File 1993-0042

Name: The Atrium of Grand Valley Retirement Village-Rezone/PP-SE Corner F 1/2 Rd. & 12<sup>th</sup> Street

TITLE HEADING: Rezone & Preliminary Plan - The  
Atrium of Grand Valley Retirement  
Village

ⓑ SITE SECTION @ TWO STORY BUILDING

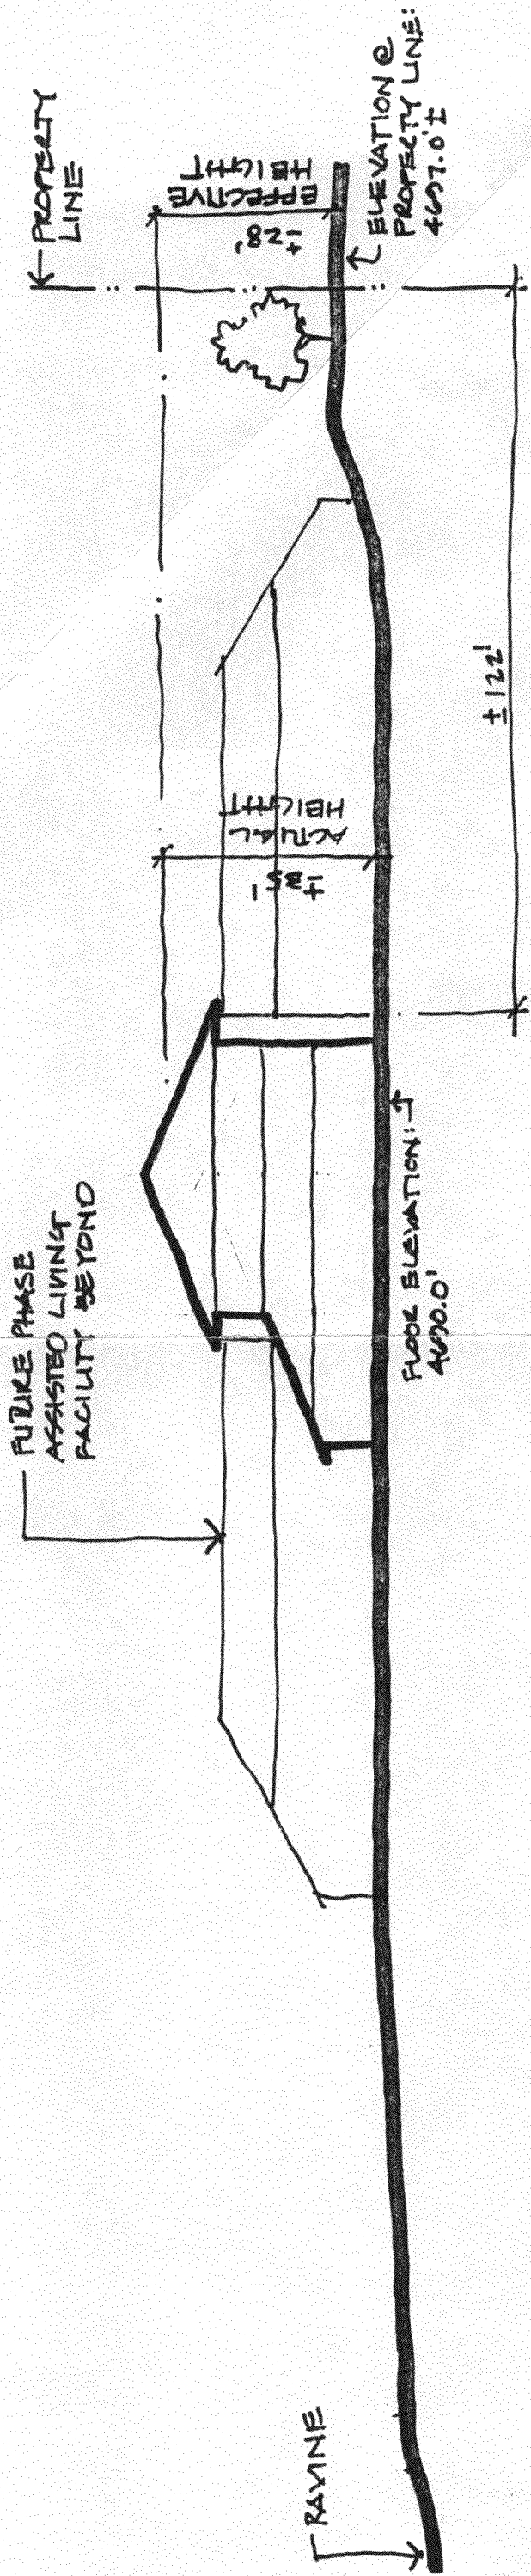
Yet another attempt at misrepresentation is found in the illustration B - Site section of a two story building. This section or cross section is so selected as to be in the East terminal section of the building. It represents 8 to 12 of the proposed 124 units. Showing 10% of the project as a representation of the appearance of the project is only an further illustration of the intent to misrepresent facts and deceive people about the reality of the plans.

**HILLTOP MINOR SUBDIVISION  
 GRADING AND DRAINAGE PLAN**

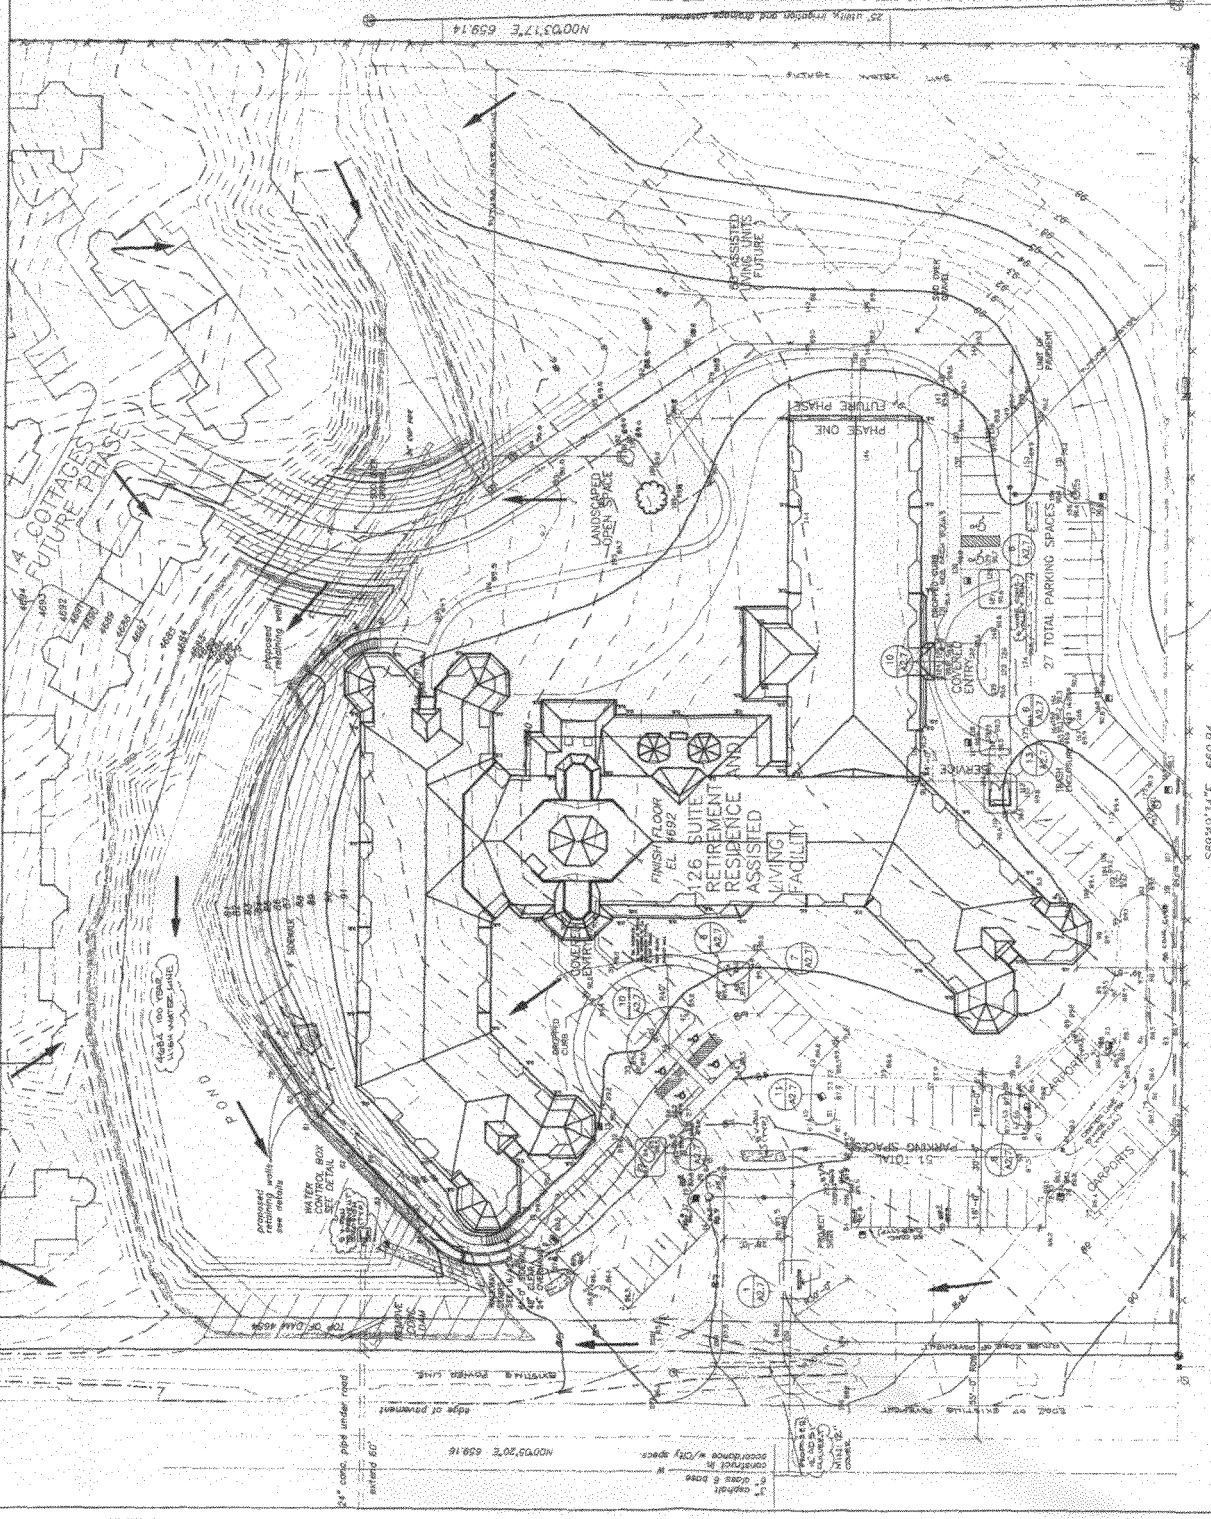
- 1R. This is a grading plan without grades!! Over 17 feet of drop occurs over the span of the building, with the bottom floor at apparently the same elevation (the finish floor level is not provided here either). Even so, proposed regrading or contours were not provided. What is the proposed grading scheme? Slopes transverse to fire lanes may not exceed 5%. Provide contours. We note that contours are provided on the architects drawing, which will be discussed hereinafter.

- 2R. This is also a drainage plan, and other than an improved pond outlet, no drainage facilities are shown, nor is an overall drainage scheme. At the preliminary level, valley gutters, swales, pipes, inlets, erosion protection facilities, and drainage arrows (as alluded to in the legend) should be shown at the preliminary level (see SSID manual page 1X-26). For final plan level, see comment (8) below.

- 3R. Grading and drainage should address inflow from off-site to the east and south.
- 4R. The Grading and Drainage Plan should incorporate changes made to the Site Plan and Plat.

- 6F. The outlet works lacks detail. Reinforcement must be specified. The walkway is without specs, handrail, and is of very questionable merit. Located adjacent to an arterial road, it appears to be an "attractive nuisance" for children, bringing undesirable liability to owners and inviting tampering with baffle settings and other vandalism. It would be recommended to either infill to the structure, or, because the design allows for overflow into the top in case of orifice clogging (a good design approach), perhaps maintenance by use of a ladder during non-storm periods is a safer way to go. Either way, we suggest having a grate over the top of the structure for safety purposes, which would require specifications and details as well. Also, show on the profile the 2 and 100 year hydraulic gradient in the culvert up to the structure, and the ponded surface elevations.

- 8F. Final plans must show refined contouring, retaining walls (if any), all grades at grade breaks, grade changes, swale end-points, points of tangency and curvature for concrete facilities, slopes between grades, best management practices, etc. Reference is made to the SSID manual page 1X-16.
